REMARKS

I. Drawings

FIG 5

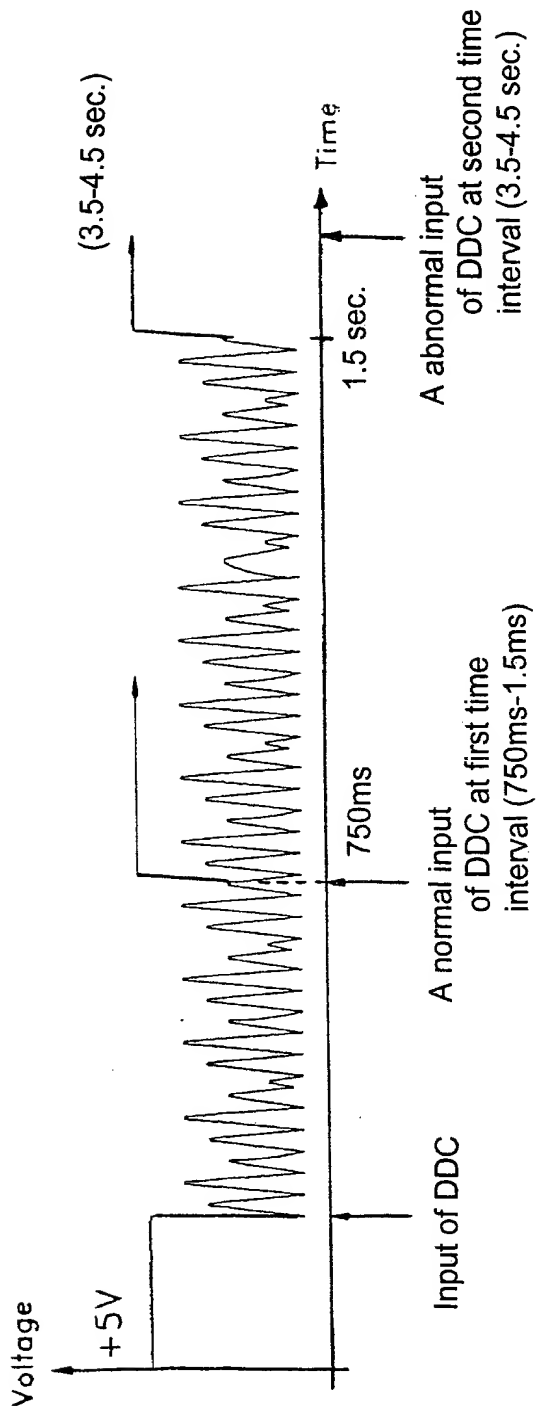
The Examiner objected to the drawings because the Examiner stated that the relay 20 comprising "R1 and R2" should be read --R3 and R4--. Figure 3 has been updated according to the Examiner's suggestion, but with R1 amended to R4 and R2 amended to R5 because as seen below R3 is already used. Further, in order to assist the Examiner in expediting the compact prosecution of the present application, a similar amendment was made in figure 5. According to 37 CFR 1.121 Manner of making amendments in application:
